ADDENDUM NO. ONE TO THE BIDDING DOCUMENTS FOR:

111 Upgrade MRI Suite
VA Project No. 695-14-145

**VA Medical Center
5000 West National Avenue
Milwaukee, Wisconsin 53295**

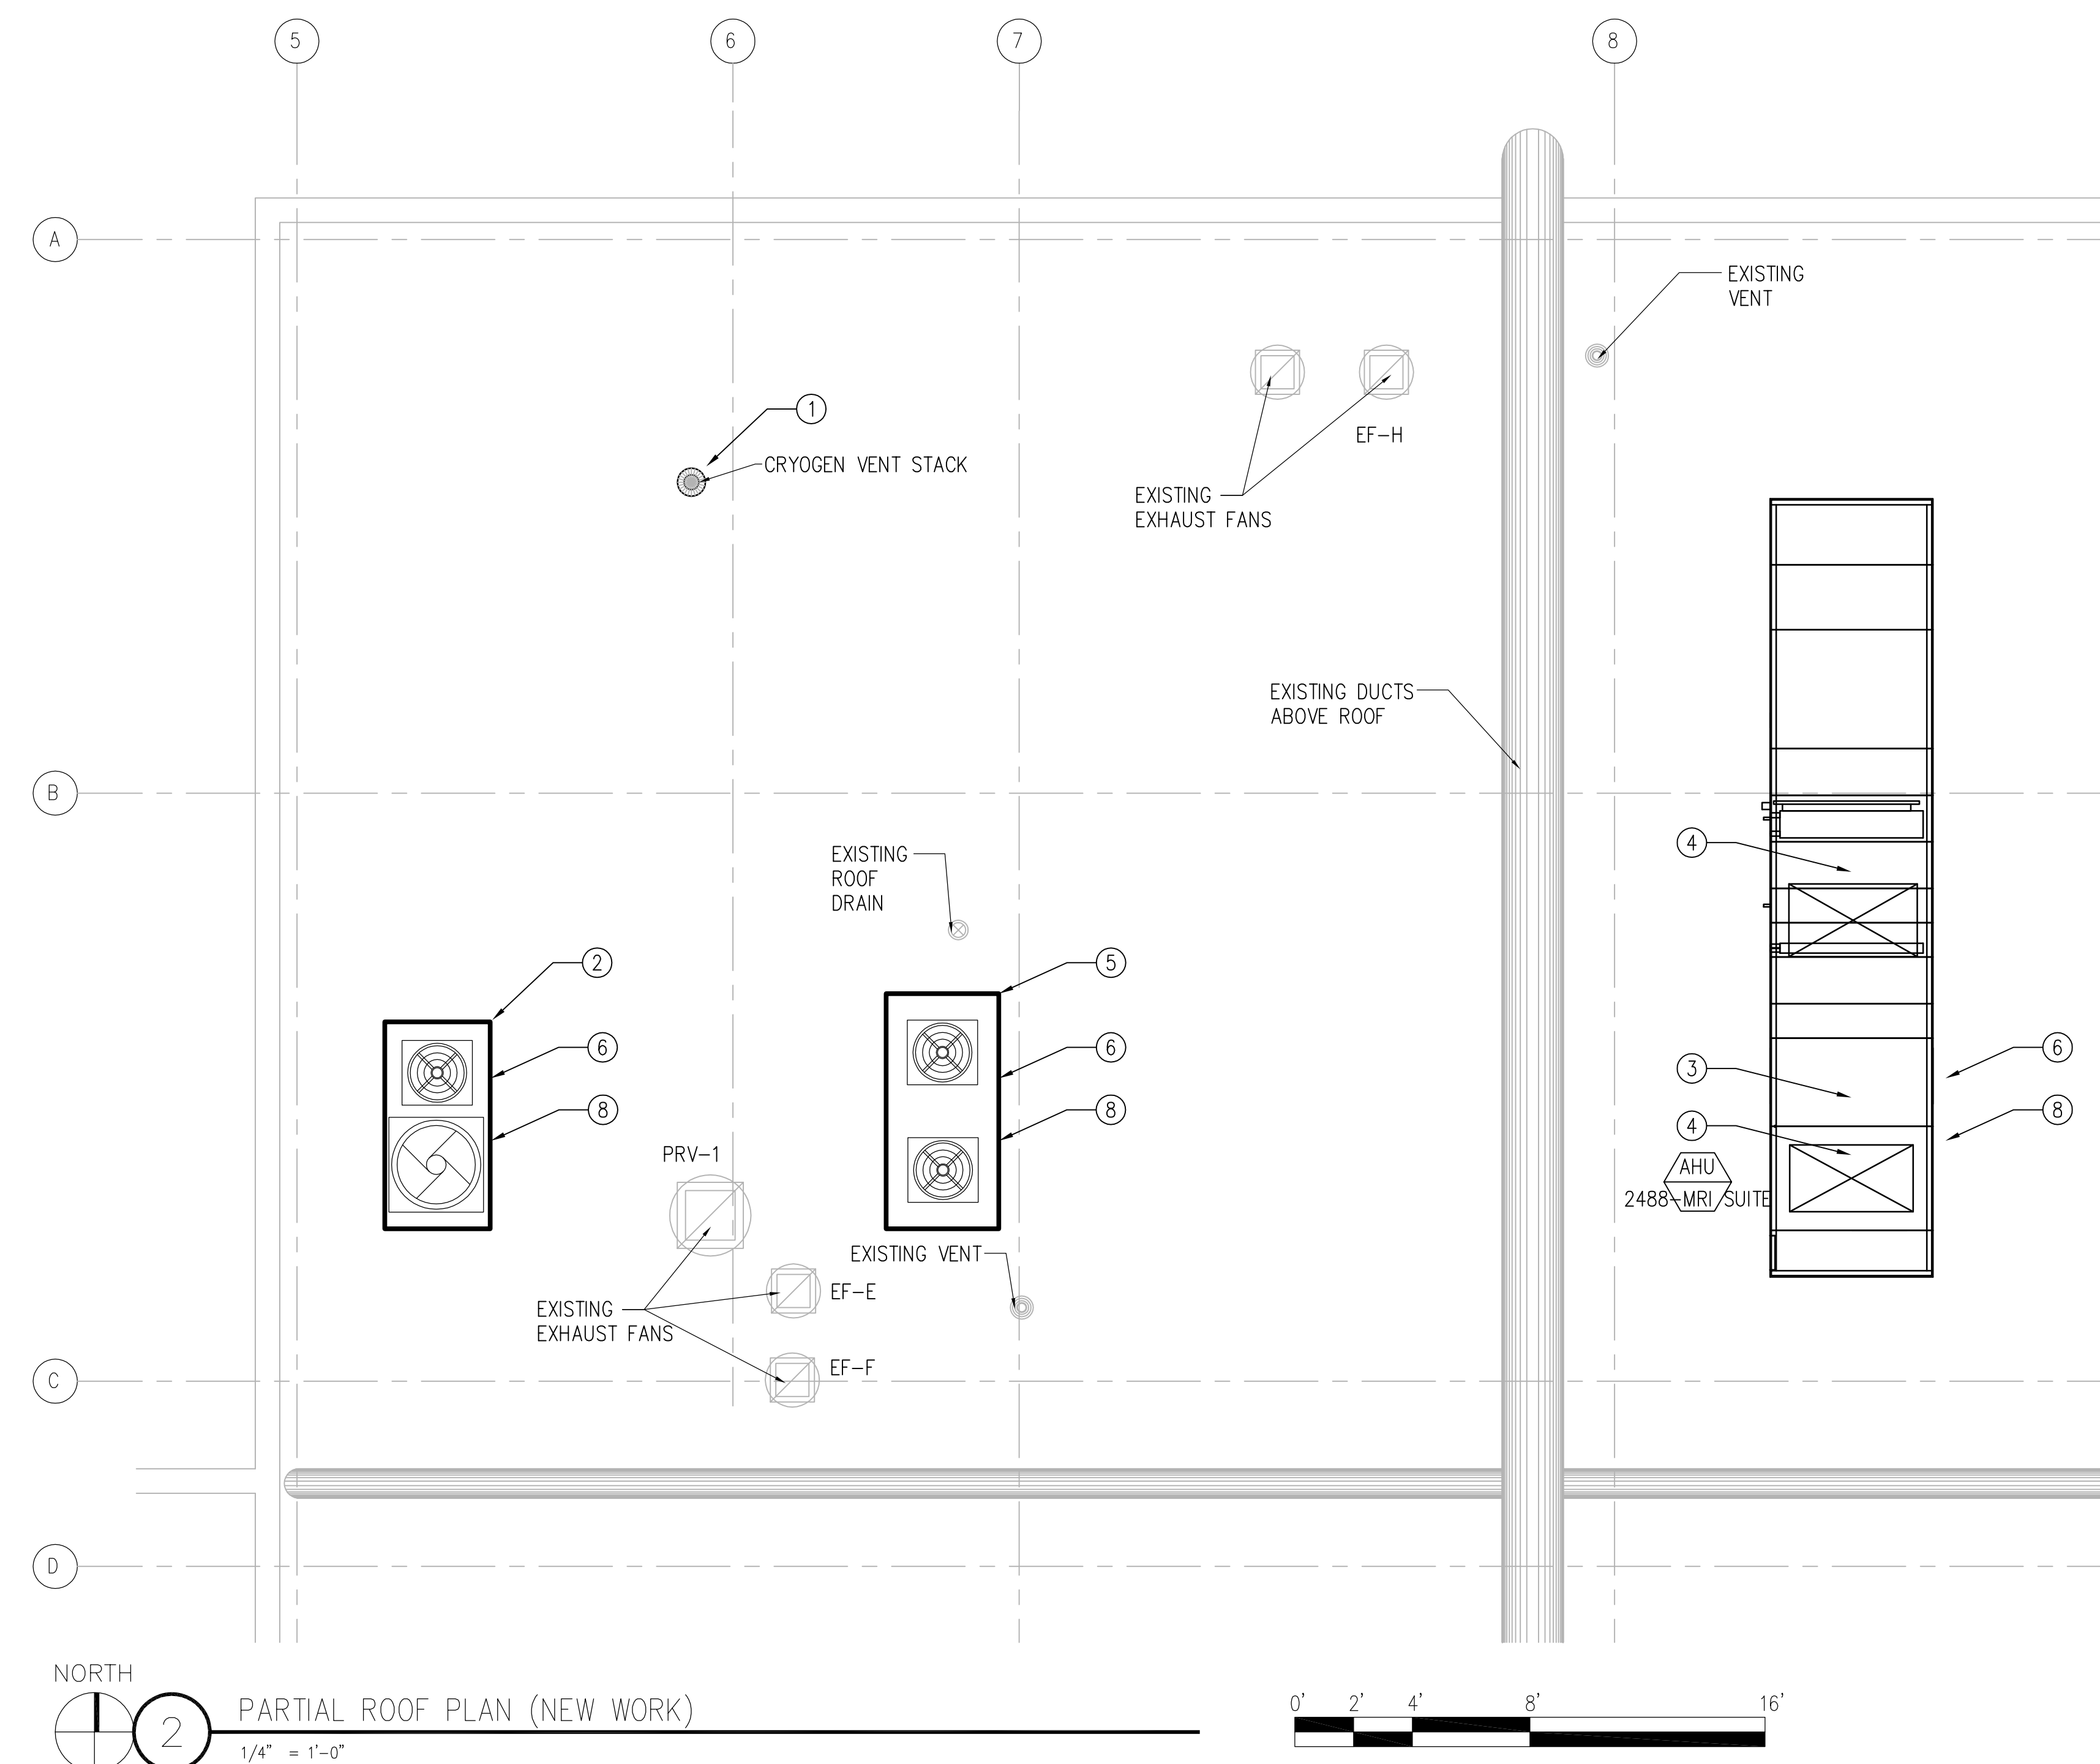
Drawing SHEET A-103:

- 1.1 Description – Demolition Roof Plan Notes added.
- 1.2 Description – Roof Plan Notes added.
- 1.3 Description – Partial Roof Demolition Plan Shows areas of the existing rubber roof, roof curbs, and chiller support rails to be removed.
- 1.4 Description – Partial Roof Plan (New Work) provides areas where new rubber flashing, rubber roof curbs, and any areas where Contractor will furnish and install roofing system infill at mechanical equipment.

Question #22: Are there details about roof demolition?

Response: Please see revised drawing SHEET A-103, 1/Partial Roof Demolition Plan and 2/Partial Roof Plan (New Work). Roof demolition notes and new roof plan notes will be provided on SHEET A-103.

Project Title 111 UPGRADE MRI SUITE		Project Number 695-14-145	
Location CLEMENT J. ZABLOCKI VA MEDICAL CENTER MILWAUKEE, WISCONSIN		Building Number 111	
Date 1/5/2015		Checked TS	Drawn PTP
		Drawing Number E-101

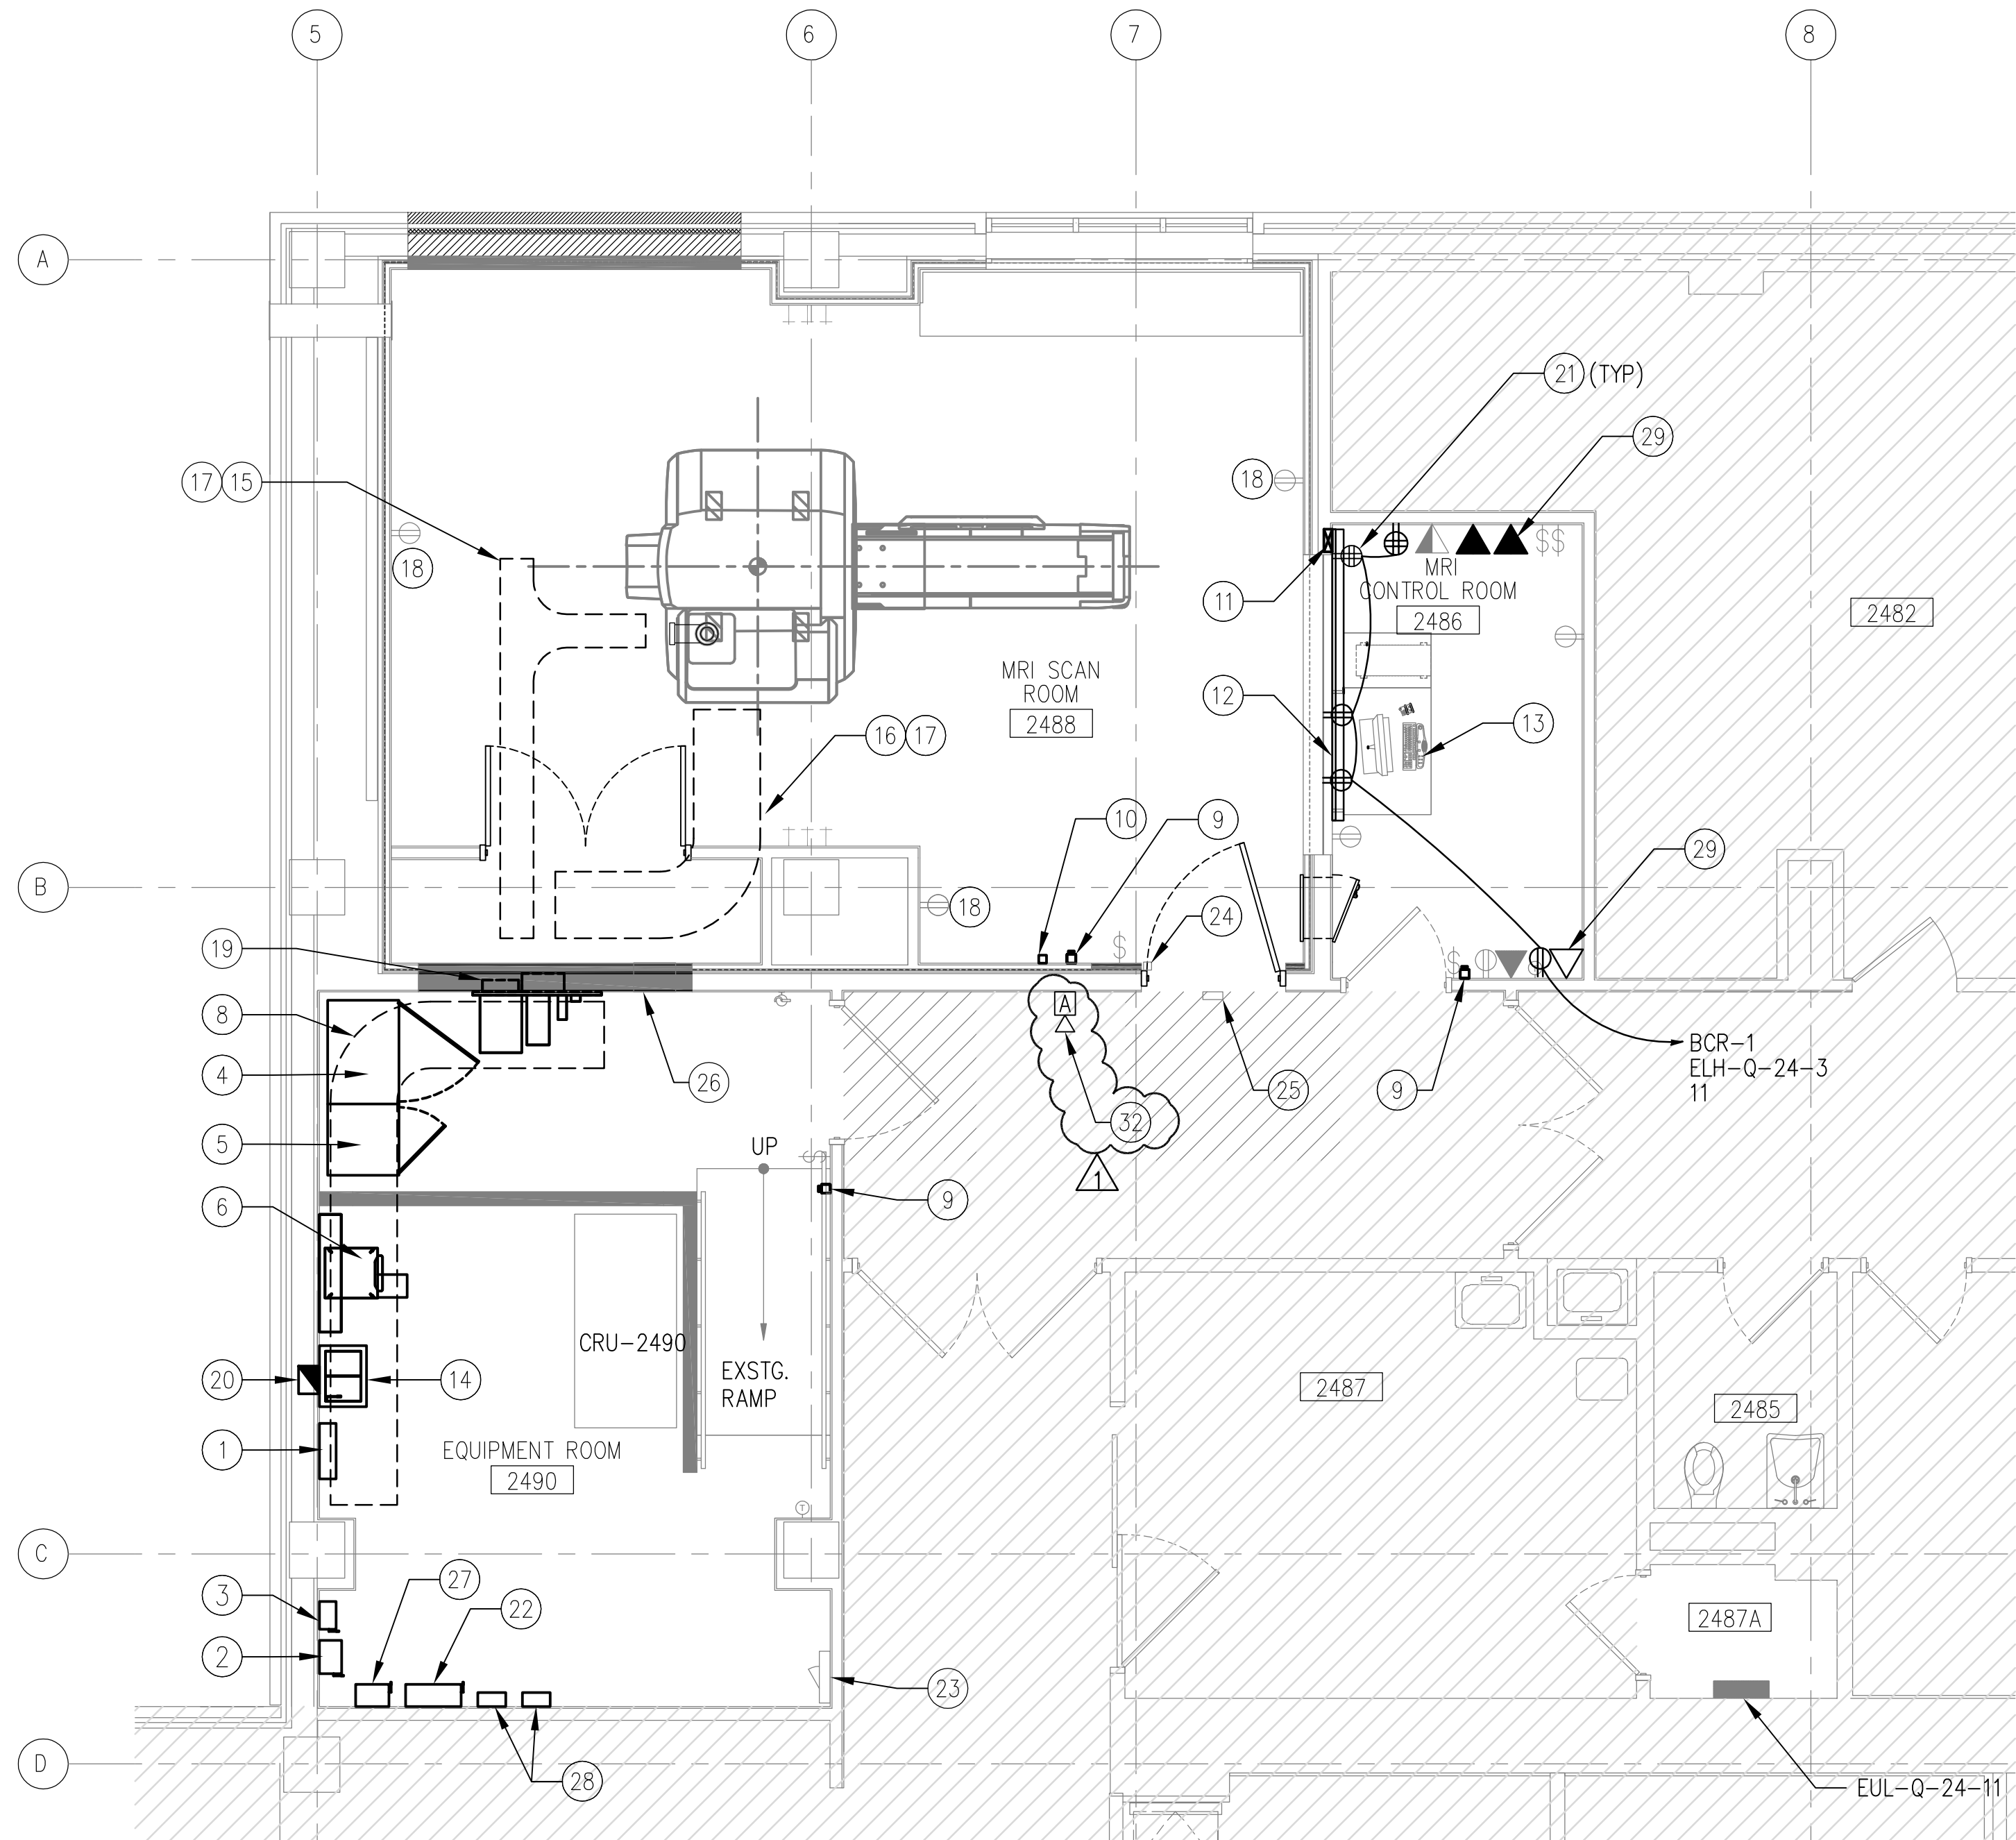
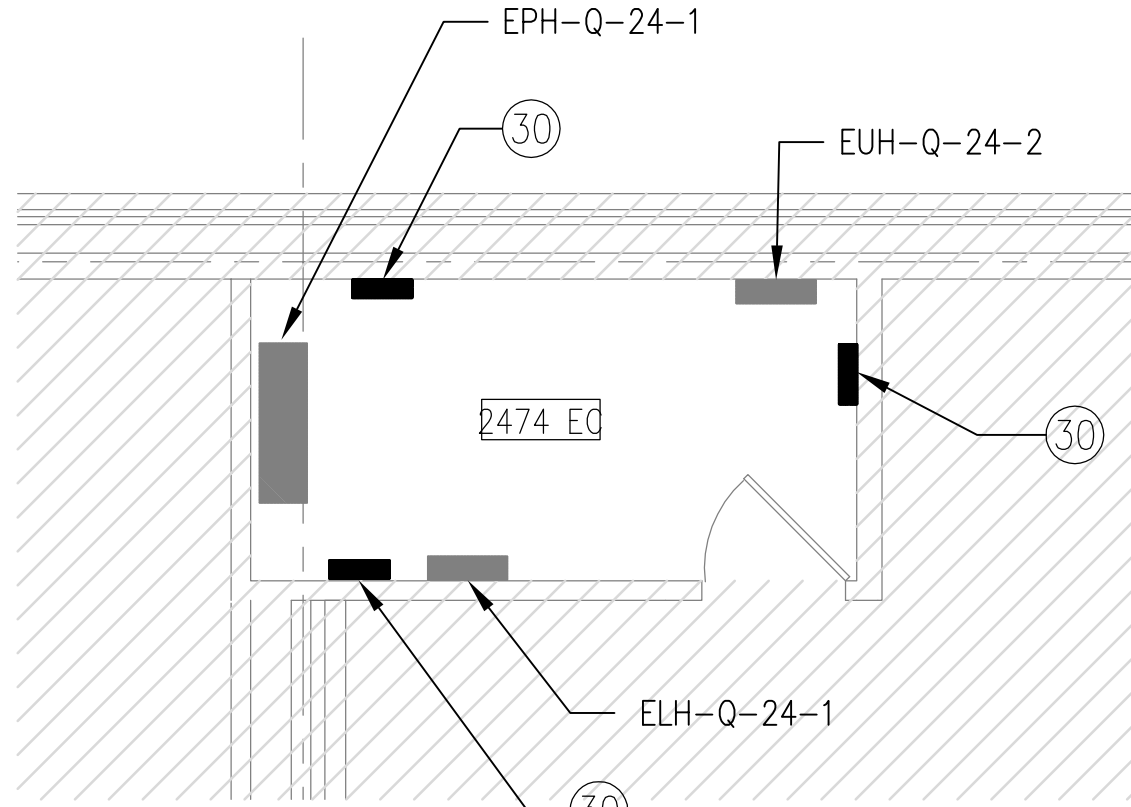
Drawing SHEET E-101:

- 1.1 Revised – Key Note #29. Location of existing data rack and telecommunication terminal is provided. Existing data rack and telecommunication terminal are located in the Fiber Closet, Room 2600AB.
- 1.2 Description – Key Note #32 added. Existing fire alarm and strobe will be relocated east, just outside of the temporary construction barrier wall. This will be fire alarm and strobe and permanent location

Question #10: The existing data rack and telephone terminal board listed in note #29, on drawing E-101, cannot be located. Can a drawing showing the location of this room be provided? Since the location of the room talked about in note #29, drawing E-101, is not identified, we were unable to view this room at the walk through. Can another walk through of this room be provided?

Question #16: Drawing E-101 - Is the aluminum ladder tray referred to in note 8 open top or is it to have a cover?

Question #17: Is the aluminum tray referred to in notes 15 and 16 to be ladder type as described in note 8 or is it to be solid wall tray with cover?

Response: The existing data rack/telephone terminal board is located at Room 2600AB. Refer to revised Sheet E-101, Note 29.

Response: Provide open top ladder tray.

Response: Provide open top non-metallic ladder tray.

- 29 CONTRACTOR SHALL PROVIDE NEW DATA AND TELECOMMUNICATION WIRING IN NEW CONDUIT FROM EXISTING DATA RACK AND TELEPHONE TERMINAL BOARD LOCATED IN FIBER CLOSET ROOM 2600AB. CONTRACTOR SHALL OPEN WALL FOR INSTALLATION OF CONDUIT AND GANG BOX FOR NEW VOICE AND RECEPTACLE.
